**ATTACHMENT 5 – WorleyParsons Review of the West Moreton Reference Tariff
Capital and Maintenance Costs – Redacted**

West Moreton Reference Tariff Submission Review

Queensland Rail is transporting coal from the West Moreton region to the Port of Brisbane. The quantum of transport charges has to be approved by the Queensland Competition Authority, the approved rate being derived from capital and operating costs approved by the QCA. Queensland Rail has submitted their initial programme of works to QCA for four years until 2017, and has requested WorleyParsons to examine and support the submission. WorleyParsons has examined the submitted documents, background documents, has inspected the track and structures, and had several discussions with Queensland Rail staff to develop this document. In many aspects, WorleyParsons supports Queensland Rail's proposition but several questions were raised concerning some aspects, and further clarification was sought.

Figure 29 - Contaminated ballast

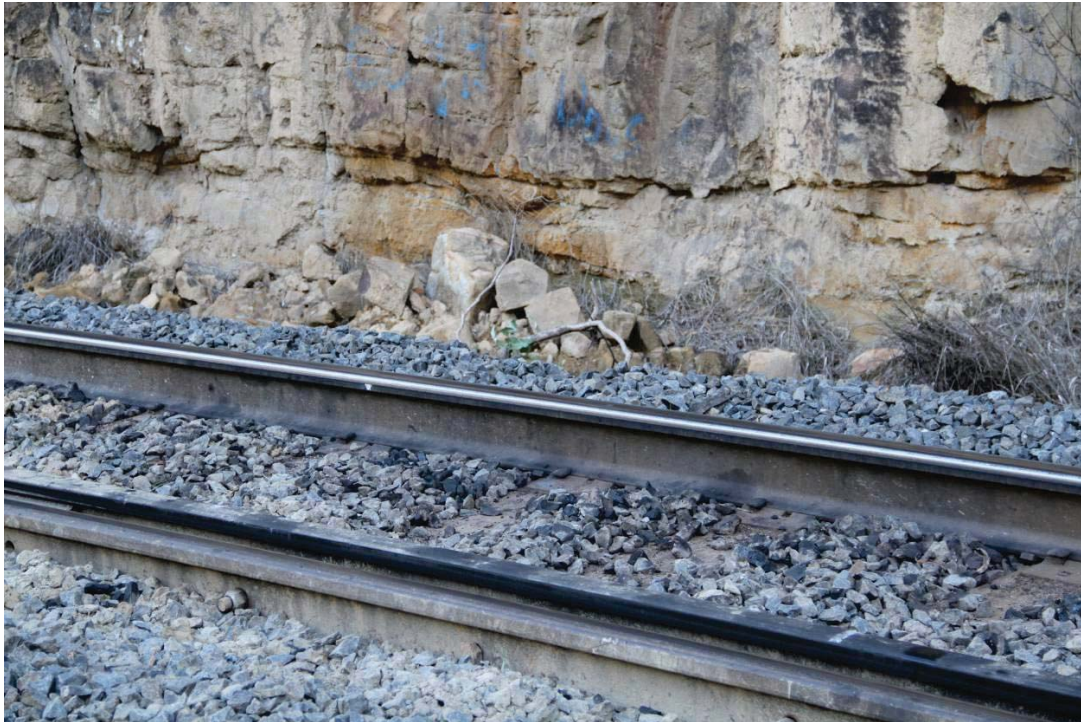
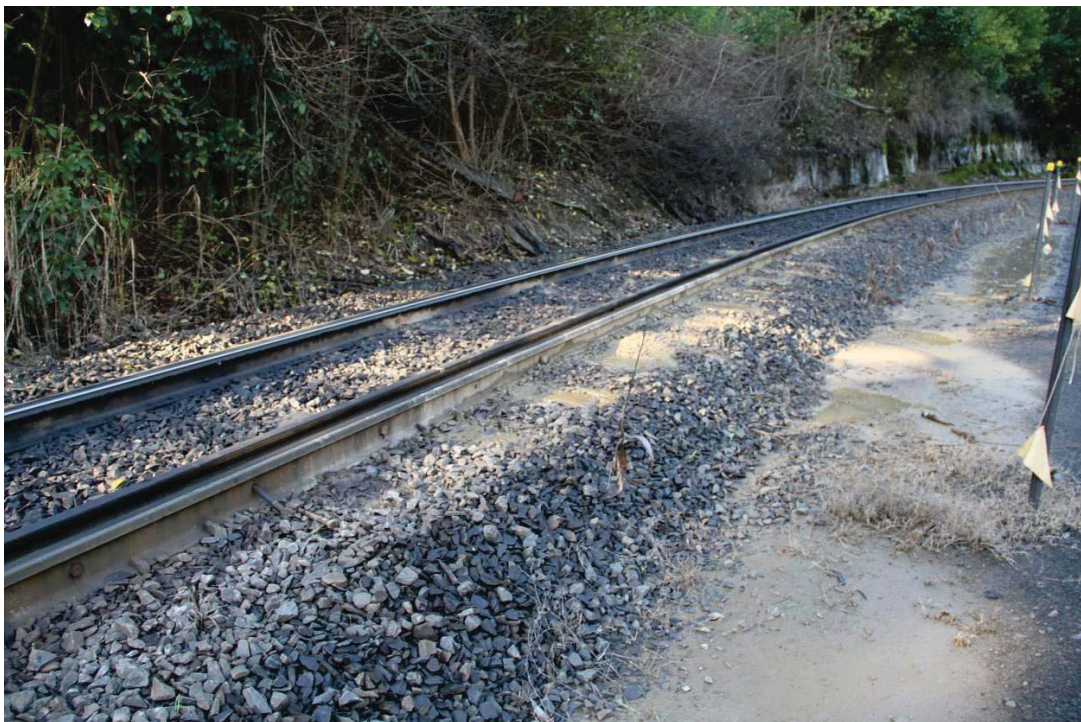
Figure 30 - Contaminated ballast and poor drainage causing pooling adjacent to track

Figure 31 - Typical turnout

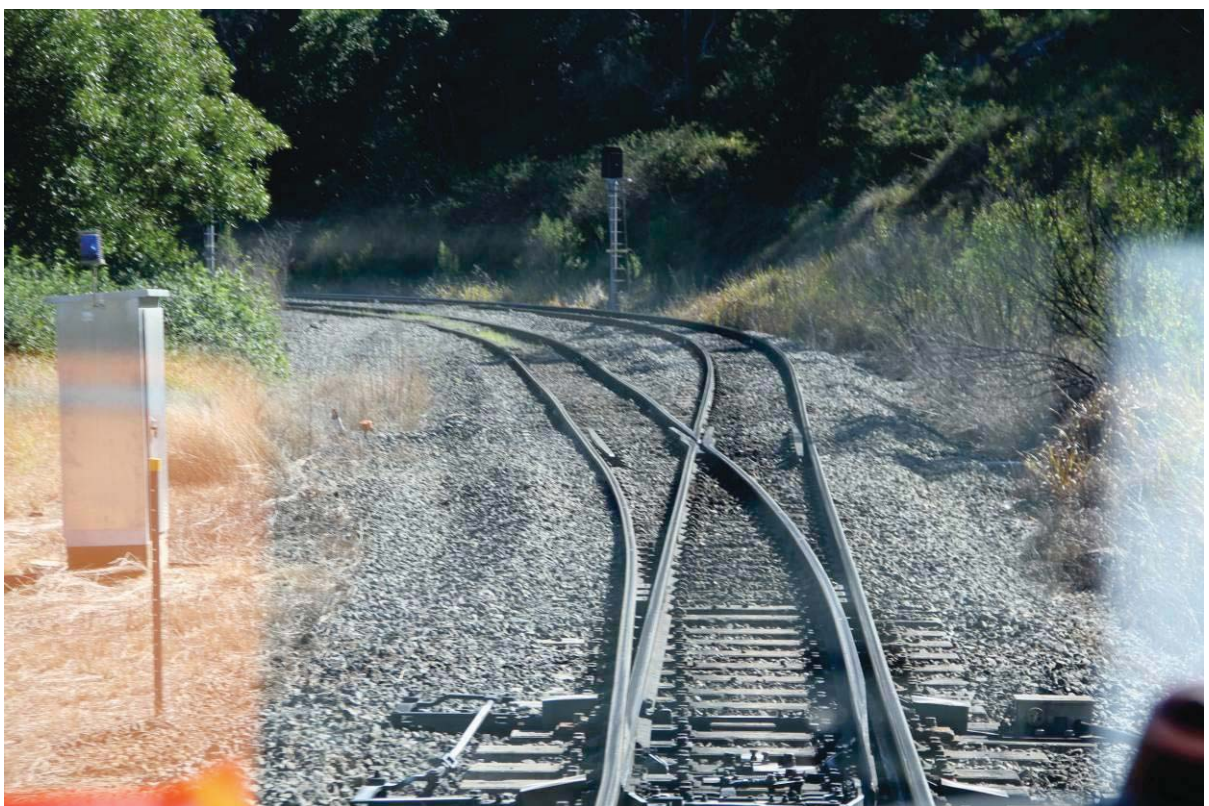
Turnouts at the six stations in the range territory are all modern designs with RBM frogs and all were observed to be in reasonable condition.

Figure 36 - Typical track section

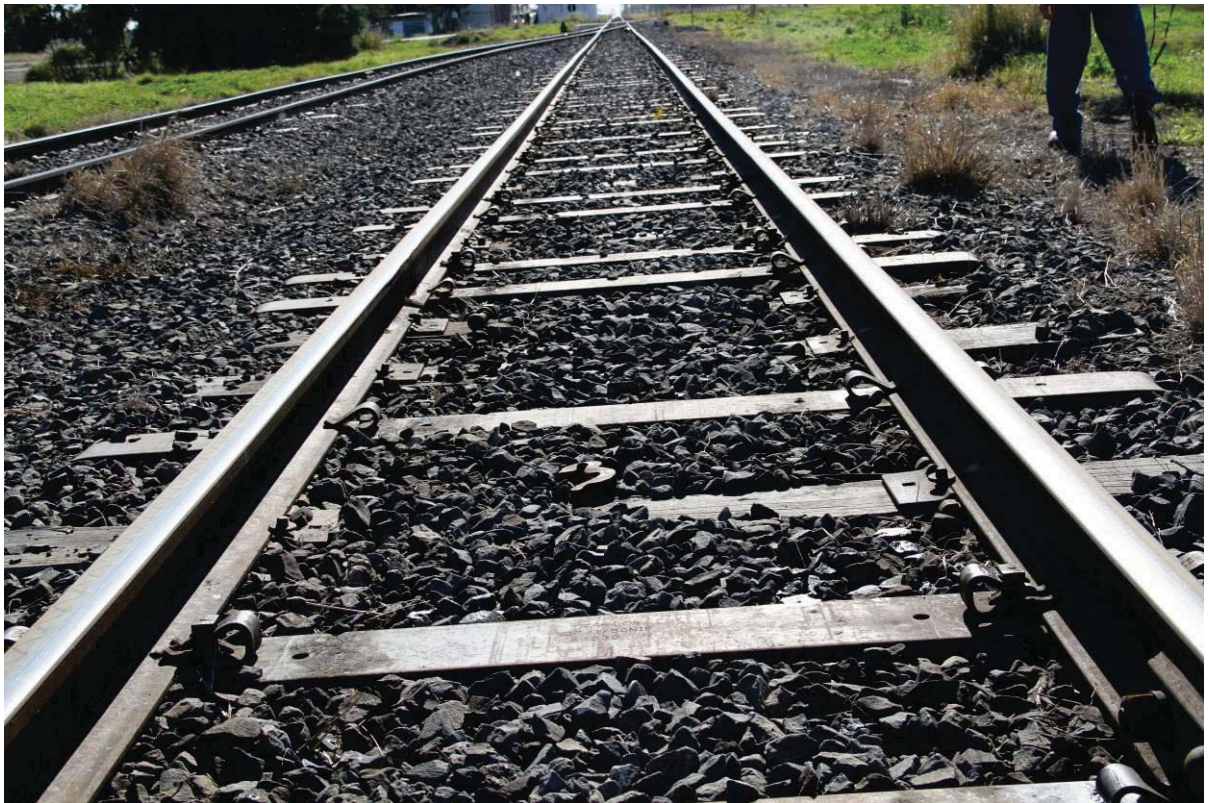
Although no detailed inspection of sleepers was carried out, it was noted that some deterioration was evident. However, overall the condition was considered fair in view of the age of the asset and the environmental conditions.

Figure 40 - Typical turnouts condition

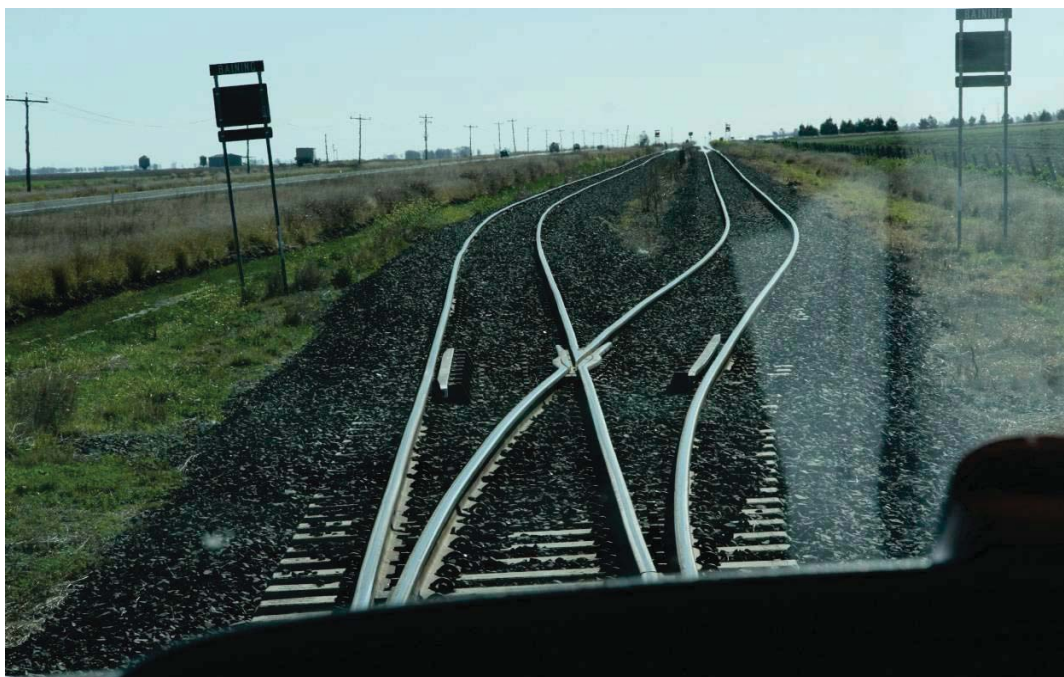
Some turnouts were found to be in relatively poor condition (i.e. Oakey 30.25km), however these were listed to be replaced or for significant reparatory works. Exclusive of these, turnouts overall were found to be in fair condition.
